Truck Bay Expansion
CMP

| Project Name: | EXPANSION OF TRUCK BAY | Project ID: | 2011-305 |
| Address: | 138 CANCO ROAD | CBL: | 148-A-006 |

RE: Central Maine Power Company – 138 Canco Road, Proposed New 874 Square Foot East Truck Bay Addition – Level II Final Site Plan Development Review Application

742-60-002
 REV A

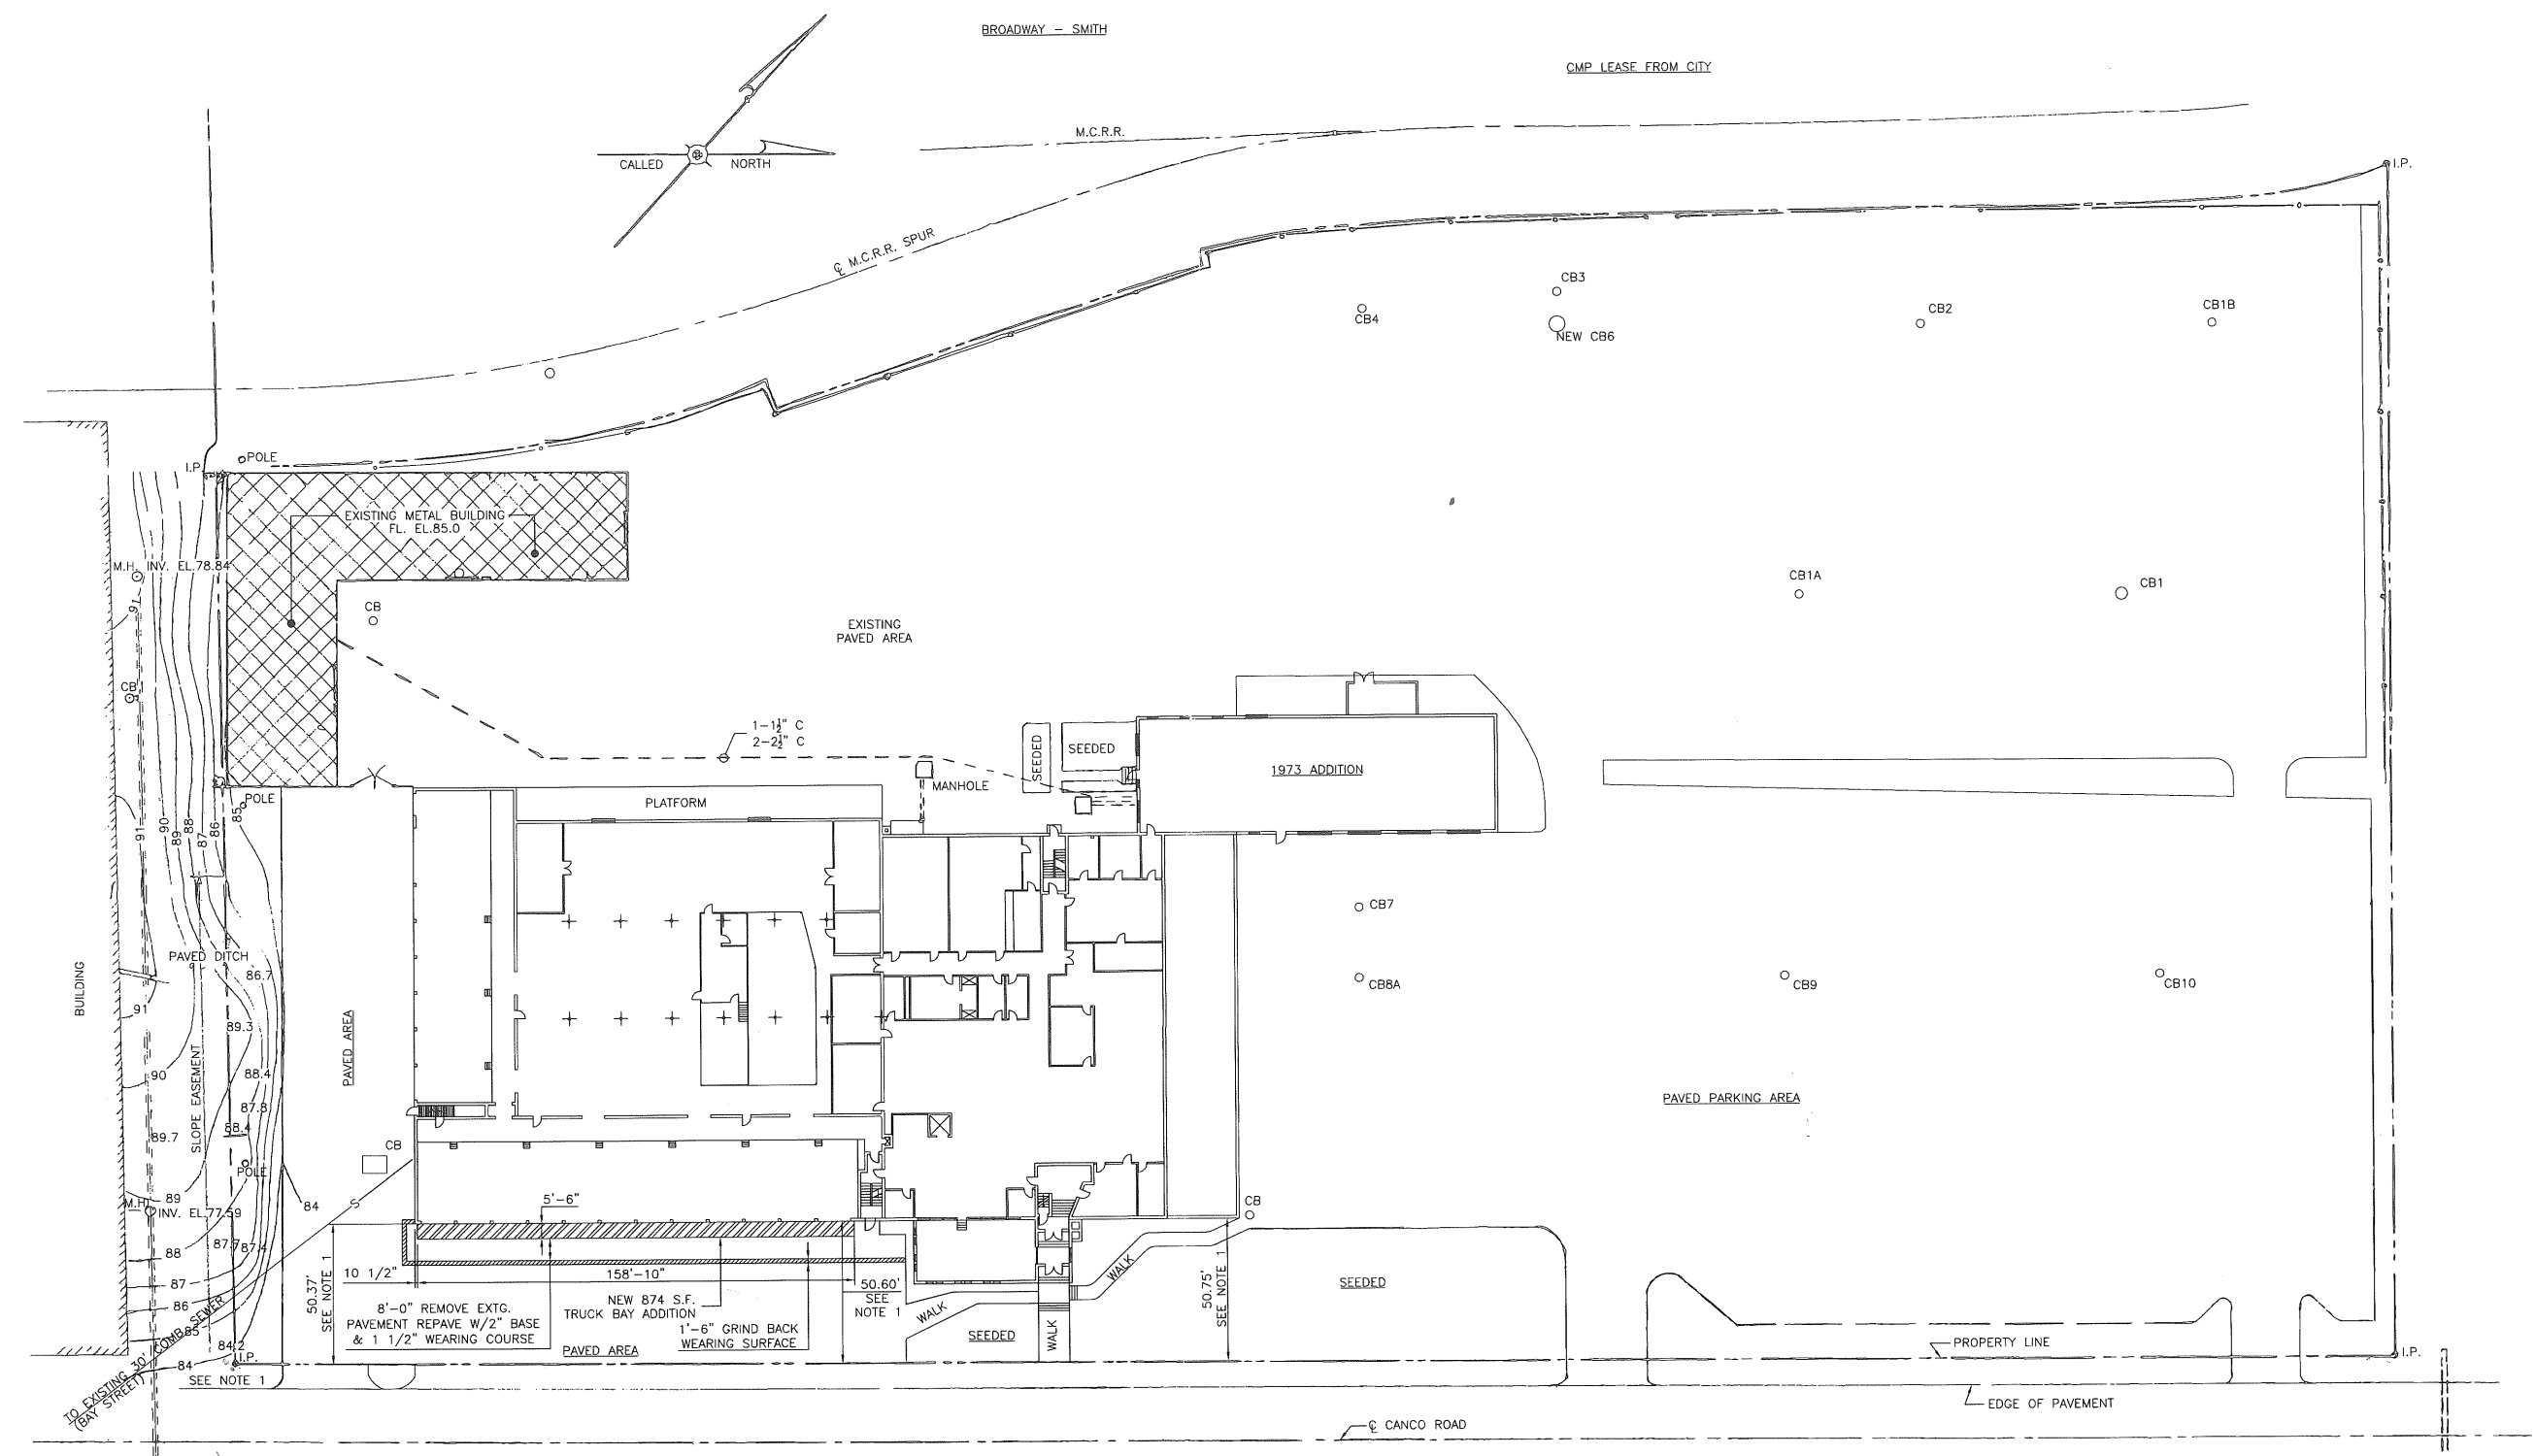
I note that the site plan is not based upon a survey. One of the requirements is a boundary survey stamped by a Maine licensed surveyor. Does CMP have a boundary survey of their site to include in the application?

Barbara, CMP does not have a licensed surveyor stamped boundary survey. They have a survey drawing that was done by their in house surveyor when they used to have an engineering department. I have attached the drawings that they currently have. I have advised CMP that the boundary survey was a part of the application, they were hoping that since the addition was in the front of the building that the deed description and the old information would suffice. If a stamped boundary survey is required we will make the provisions to get it completed. Please advise. Thanks, Dan
